DEVELOPMENT FACILITATION TEAM (DFT) APPLICATIONS

Re: Sketch Plat Review for Proposed Parcels B-1 and C-1-A, Tijeras Place Addition, located at 300 San Mateo Blvd NE and 5300 Copper Ave NE

The subject properties were evaluated for a site plan at a hearing on September 14, 2022 under PR-2022-007589; PS-2022-00191 with Planning comments for sketch plan also listing a PR-2018-001681. The sketch plat comments from the hearing on December 7, 2022 are addressed below:

Plat for Parcels B-1 and C-1-A Tijeras Place Addition Being Comprised of Parcels B, C-1, C-2, D & E; Lots 13 and 14, Block 25, Tijeras Place Addition; Portions of Vacated Ortiz Drive NE, Zia Road NE; and Tracts Identified as "3-6-EL-2" & "3-7-EL-1", Being Portions of Lots 11 & 12, Block 19, Tijeras Place Addition City of Albuquerque Bernalillo County, New Mexico January 2023

Sheet 2 of 4

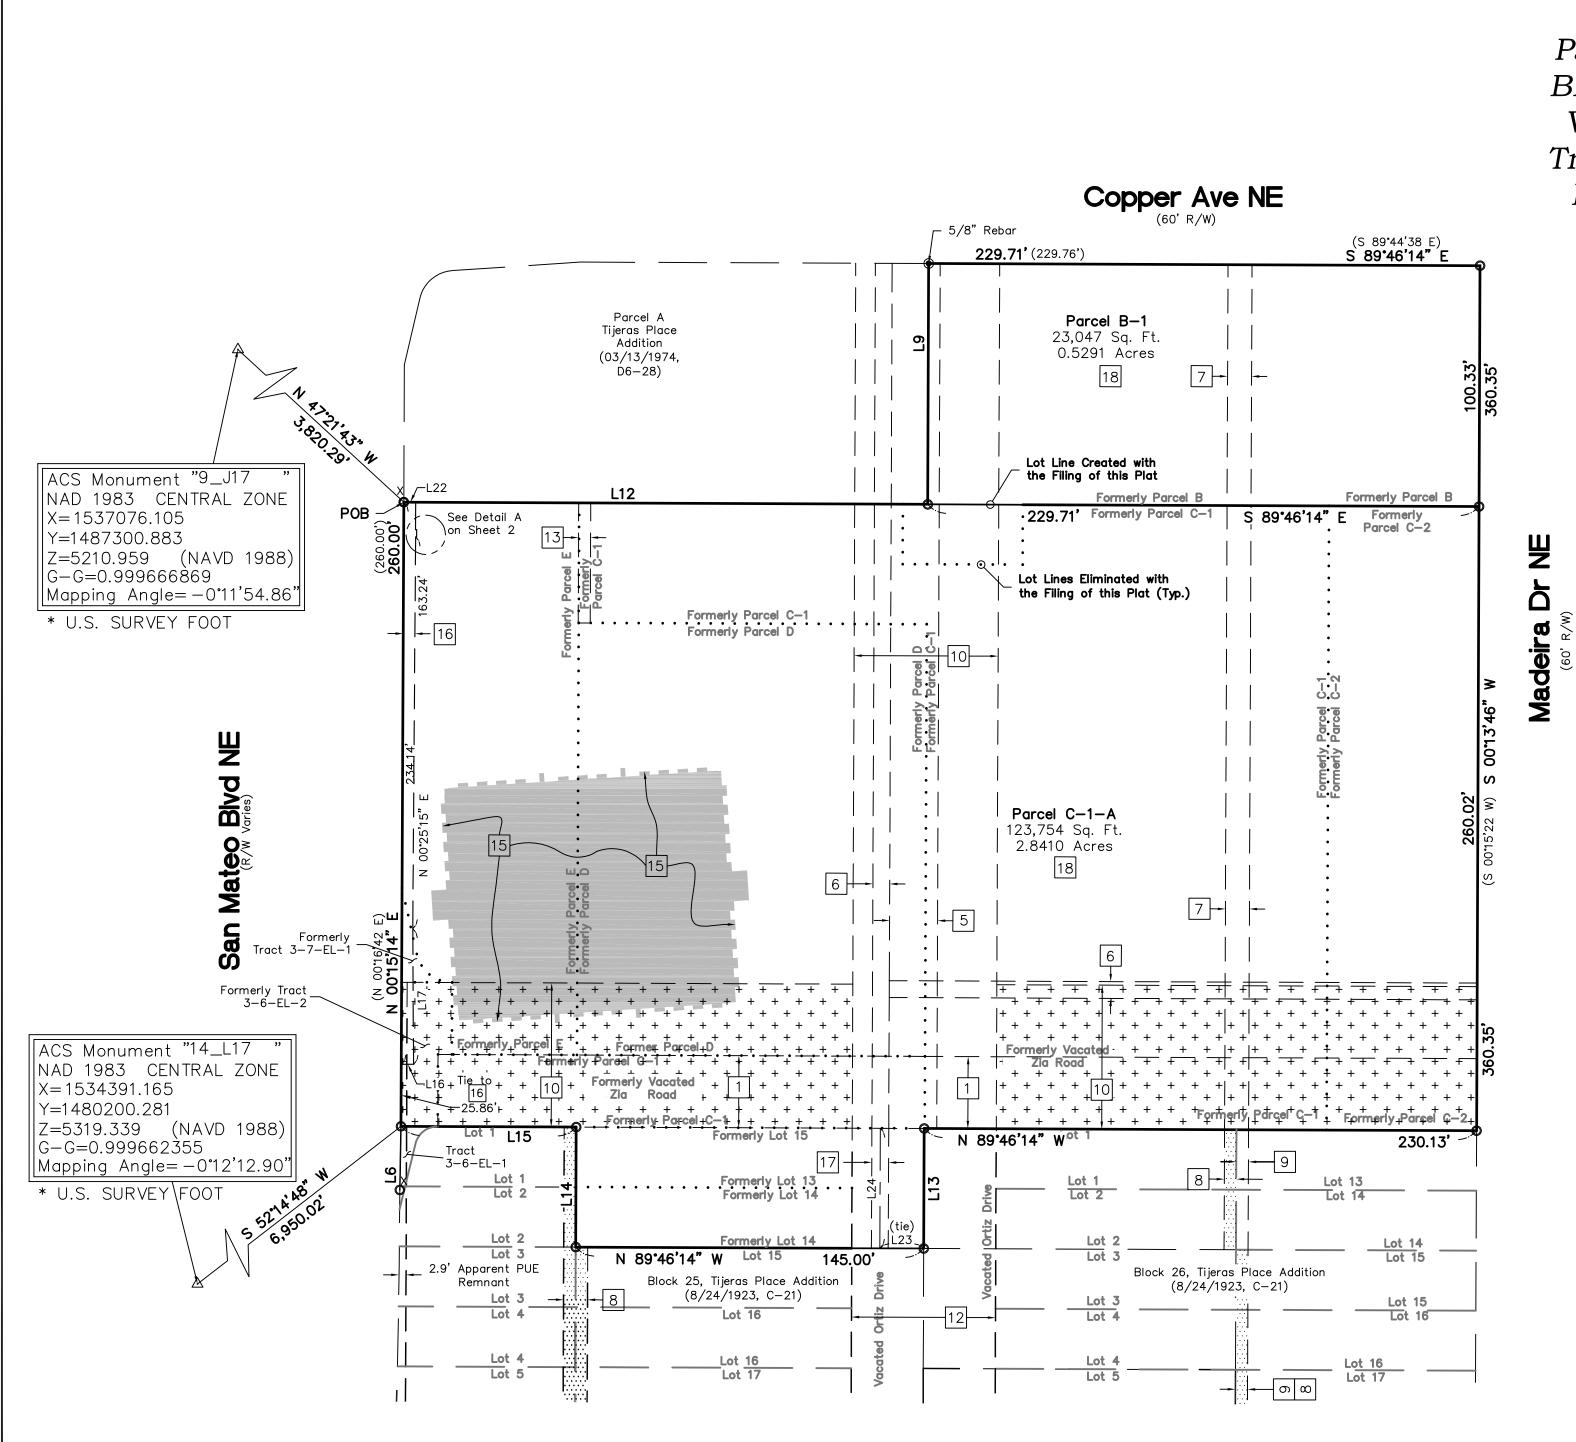
- 1. Proposed re-plat is correctly drawn along Zoning lines, to avoid mixing two zones, MX-M and MX-L. Proposed properties must meet Dimensional standards for the MX-L and MX-M zones respectively, as per IDO section 5-4(C) Compliance with Zoning Requirements.
- 2. Building crosses lot lines. This action shows a one-story building that is dissected by the newly proposed lot lines for parcel B-1 and parcel C-1-A, which is not in compliance with the IDO Dimensional Standards for setback requirements, as per IDO section 5-1(C), Table 5-1-2.

3. Parking for business located on proposed parcel B-1 appears to be located on parcel C-1-A (the same structure as noted above). Please clarify if this business is going to remain and, if so, what arrangements will be made to preserve required parking. Reference IDO section cited below:

1. San Mateo is a Principal Arterial within a center in this area and requires a 10' sidewalk. ROW dedication may be required.

Building is intended to be removed with proposed subdivision consolidating lots, and footpath leading to Parcel C-1-A created in place.

Parking for Parcel B-1 will be for use of Parcel C-1-A site, and so cross-lot parking and access easement 18 is proposed with our plat. Cross lot parking and access to the lots south of this one is not desired for future use, and is not necessary for future development plans.

Noted, public easement for sidewalk and utilities will be granted with this plat to accommodate the necessary space to widen the sidewalk to 10 feet.

Subdivision of this property is a consolidation of lots, so nonconforming elements such as the existing building setback from San Mateo are not increased by the platting action. Sidewalk requirements will be alleviated with granting of proposed public easement for sidewalk and utilities [16].
